FACPAC Contract Change Order Supplemental Information Form (Ref# 55141)

Tier 1 Project: Estill County Area Technology Center

CHANGE ORDER NUMBER: 2-6
INITIATION DATE: 6/23/2021

PROJECT NUMBERS: CMA-KDE-000704 / 18-361
CONTRACT DATE: 12/16/2019
CONTRACT FOR: BID PACKAGE #002 ASPHALT PAVING

PR-28.1
PROPOSAL
DATE: 08/14/2011
PROJECT: ESTILL COUNTY AREA TECHNOLOGY CENTER
SHEET NO.: 2011.0201
REVISED:
Copyright © Rosstarrant Architects 2011

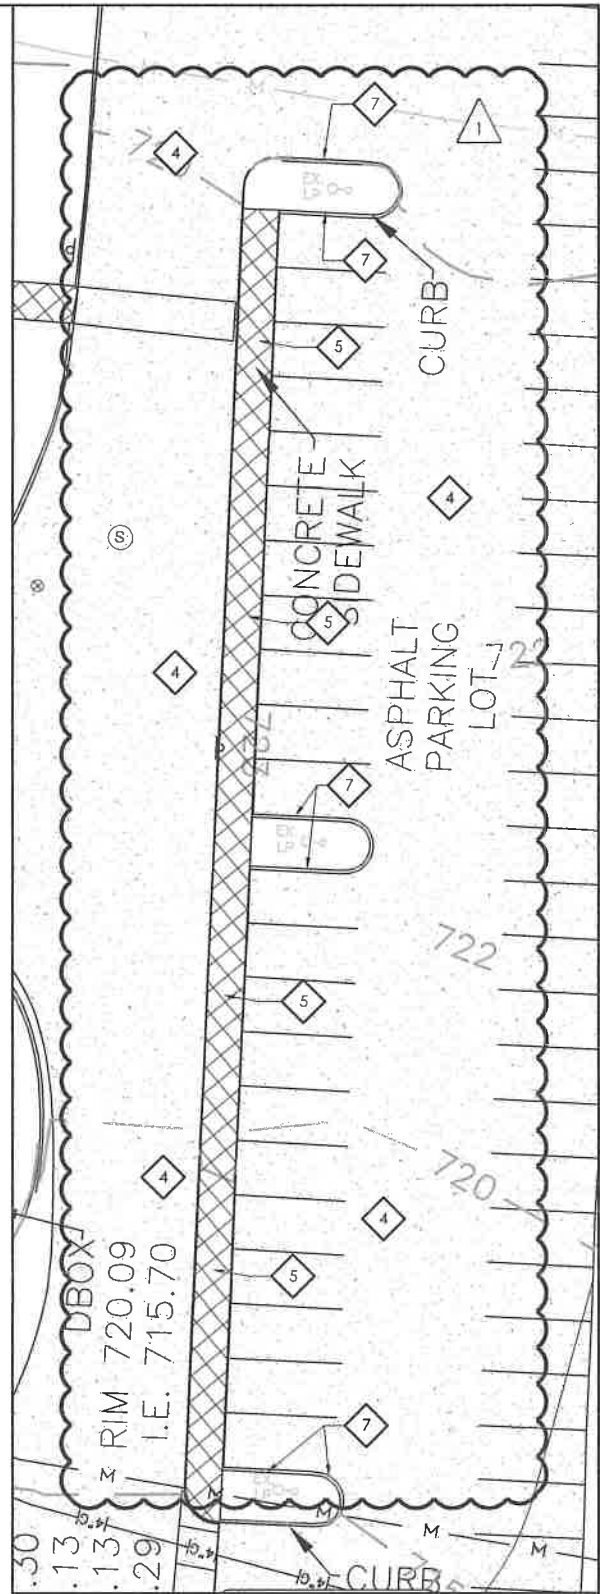
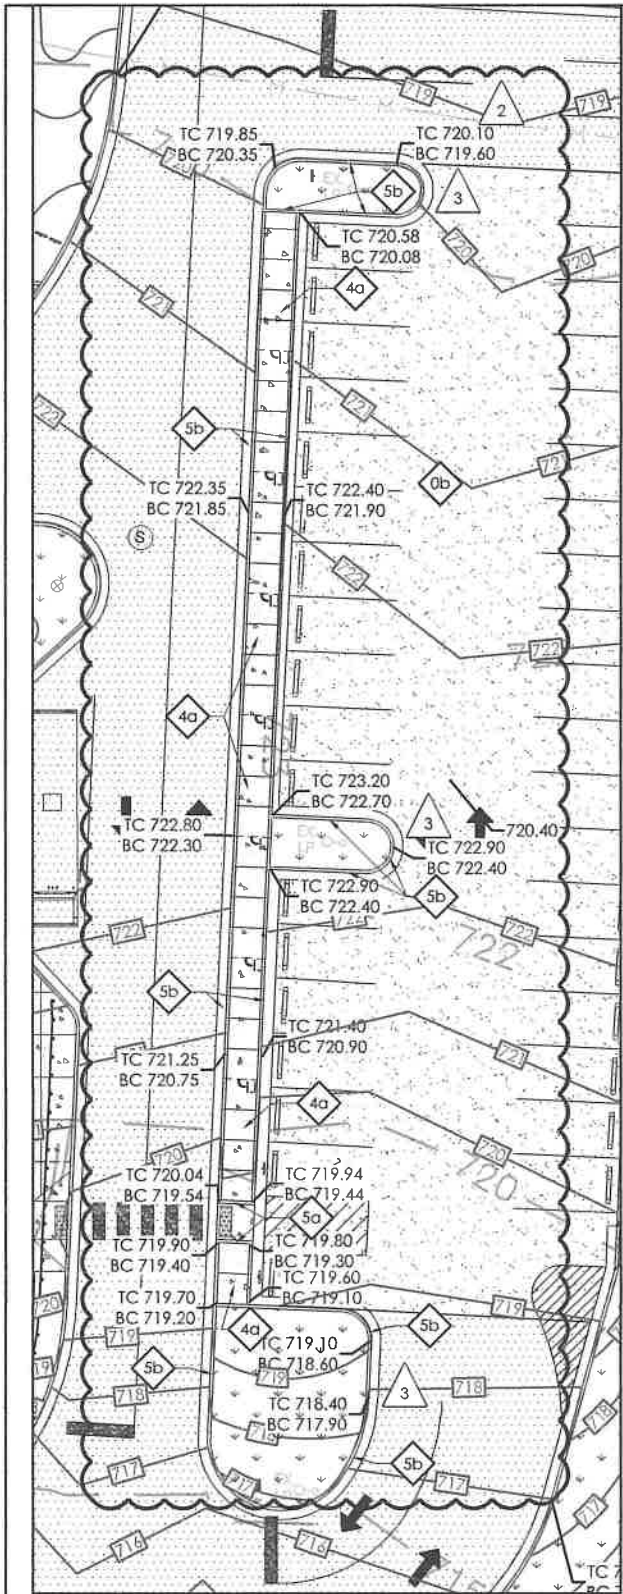
1. Demolish existing concrete sidewalk and curb as shown on the attached sketch.
2. Provide and install new concrete curb and gutter and concrete sidewalk as shown. Revise grading as shown.
3. Provide and install Sod in parking Islands as shown.

- 1 DEMOLISH AND REMOVE EXISTING CONCRETE WALK AS SHOWN. REFER TO SHEET SD0.2 FOR ADDITIONAL INFORMATION.
- 2 REPLACE CONCRETE WALK AND CURB AND GUTTER AS SHOWN. REVISE GRADING AS SHOWN. REFER TO SHEET SD3.1 AND SD3.2 FOR ADDITIONAL INFORMATION.
- 3 PROVIDE SOD IN PARKING ISLANDS AS SHOWN

CHAIN LINK ROLLING VEHICULAR GATE - ALT. #2
SCALE: 1/2"=1'-0"

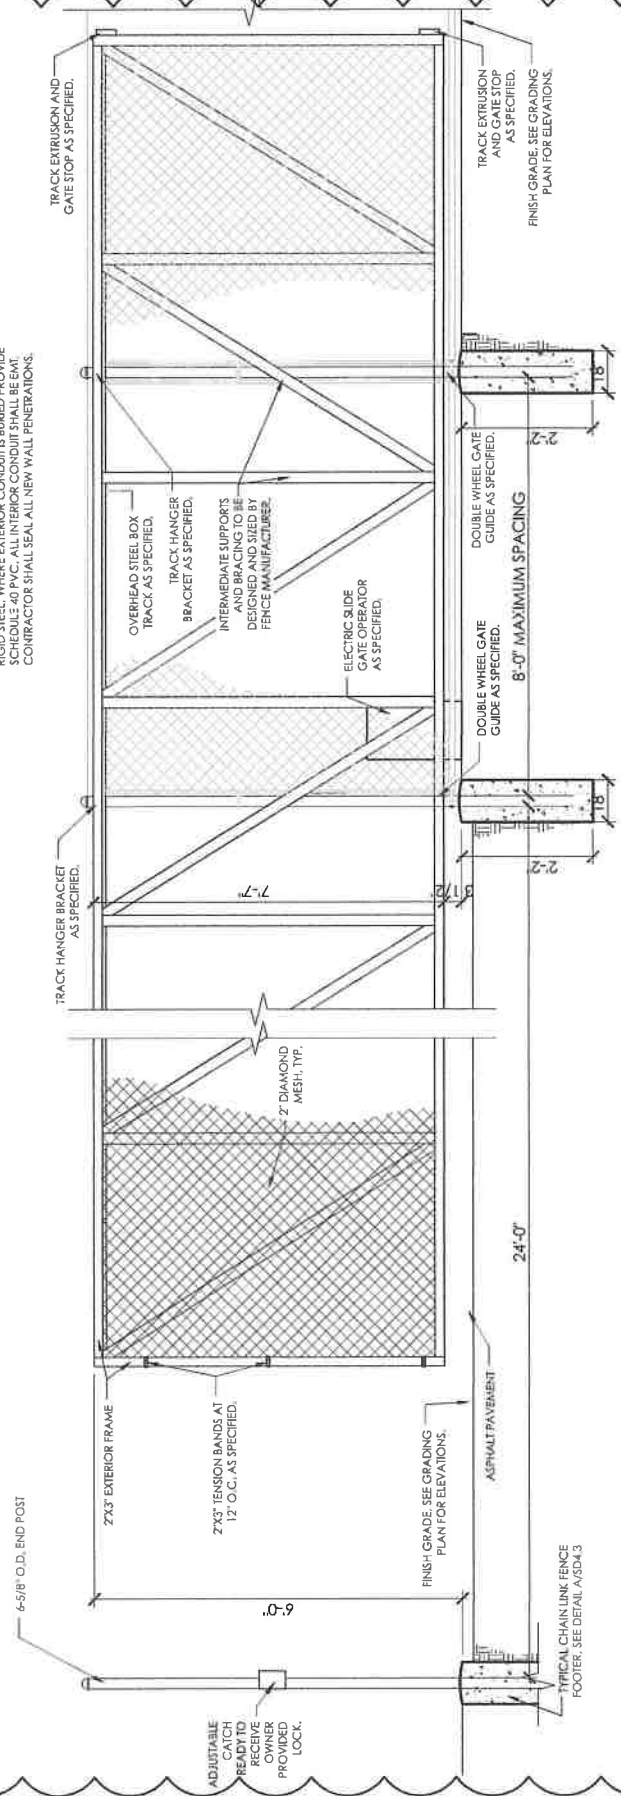
DEMOLISH AND REMOVE EXISTING CONCRETE CURB AND GUTTER. REFER TO SD0.2 FOR ADDITIONAL INFORMATION.
	ADD CONCRETE DRIVE CONNECTION, CURB AND GUTTER AND ROLLING GATE AS SHOWN. ADJUST LOCATION OF SIGNAGE AND REVISE GRADING AS SHOWN. REFER TO SD3.4 FOR ADDITIONAL INFORMATION.
	REVISE TAG LEGEND AS SHOWN.

1 ADD CHAIN LINK ROLLING GATE DETAIL AS SHOWN.
